PLANNING UNIT REPORT
DEPARTMENT OF PLANNING AND DEVELOPMENT
May 23, 2006

CONDITIONAL USE APPLICATION:

1. Requested Action: Approval to operate an outdoor eating area for a restaurant located at 617 Williamson Street.
2. Applicable Regulations: Section 28.09(2)(d)6 requires that outdoor eating areas of restaurants must obtain a conditional use permit. In addition, Section 28.04(19) regulates development on waterfront properties.
3. Report Drafted By: Peter Olson, Planner II.

DATE: May 15, 2006
TO: Plan Commission
FROM: Larry D. Nelson, P.E., City Engineer
SUBJECT: 617 Williamson Street Conditional Use

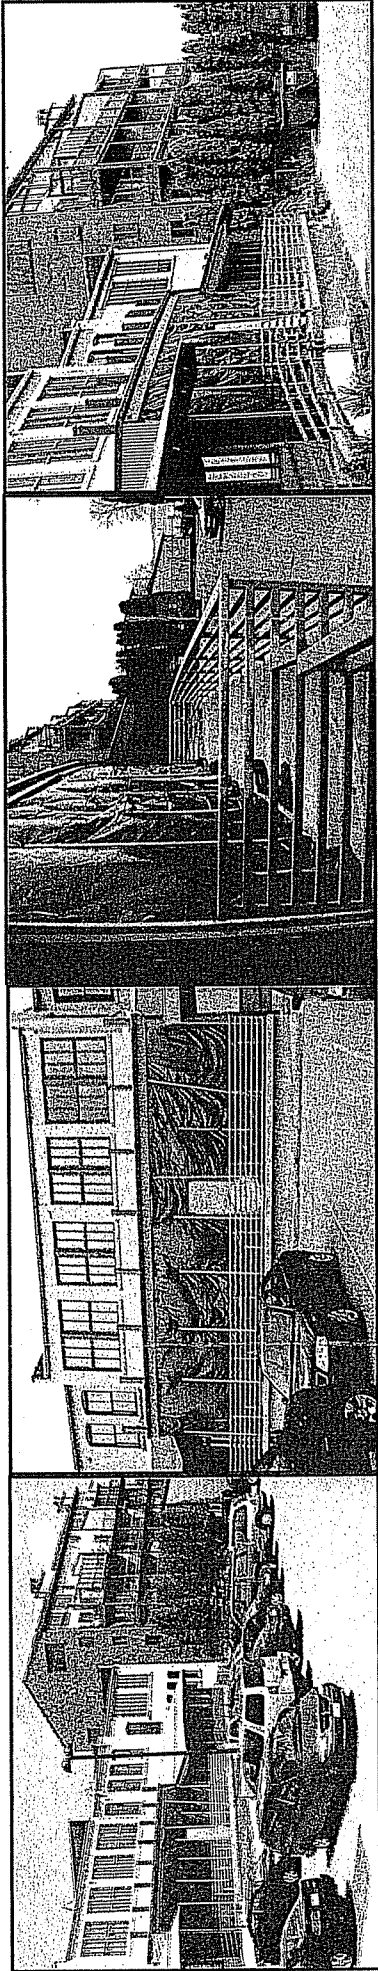
Photos of Fauerbach Proximity to Restaurant at Machinery Row--Set 1: The patio seating area is within the steel railing shown. This is where outdoor patrons will eat, drink, and smoke. The temporary black coverings will be replaced with multiple French doors across the entire width of the restaurant. These French doors could be open allowing sounds to escape to the outside from 190 restaurant and bar patrons. Some patio seats would be a mere 90 feet from the nearest condo units. The closest parking space will be just 15 feet from the living space of the closest condo.

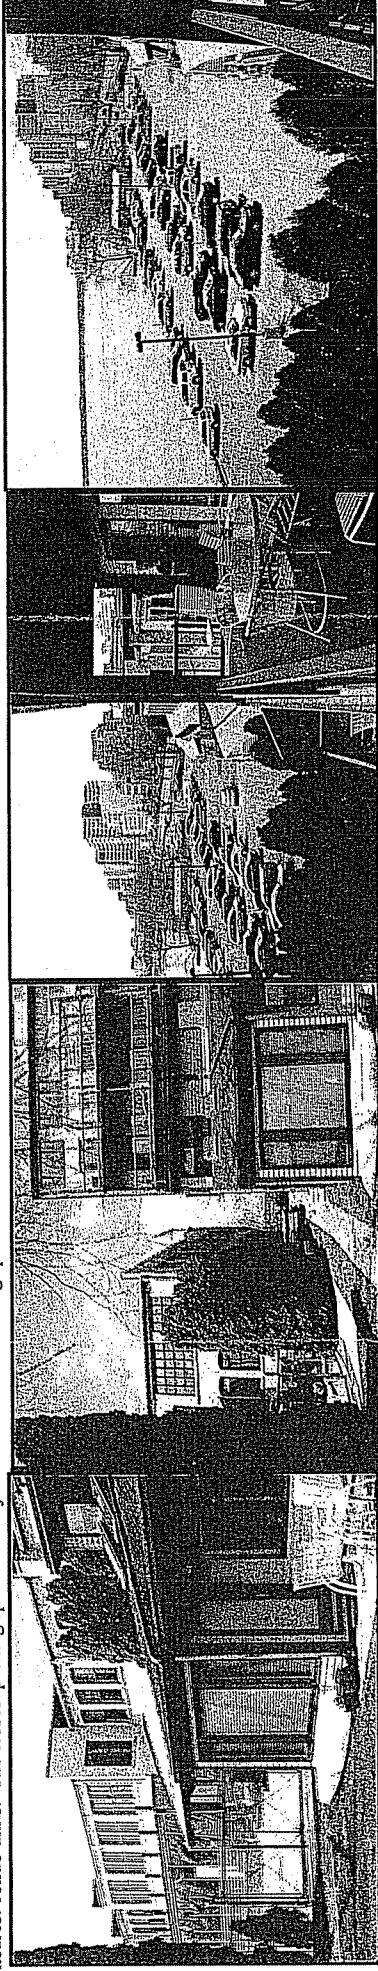
Photos of Fauerbach Proximity to Restaurant at Machinery Row: Set 2: These photos are from the property of the Fauerbach condominiums looking toward the restaurant patio seating area and toward the 70 car parking lot. The patio area is visible in the far left photo. It also is shown in the second from the right photo taken from a condo balcony about 90 feet away. Sounds from car doors, engines, and patron conversations likely will disturb the sleep of condo residents, many of whom are senior citizens, if the restaurant-bar operates after bedtime hours.

Accordingly, the Fauerbach Condominium Association requests operating conditions be imposed by the ALRC and Plan Commission on the restaurant/bar (to minimize noise from up to 190 patrons inside and up to patron 70 cars):
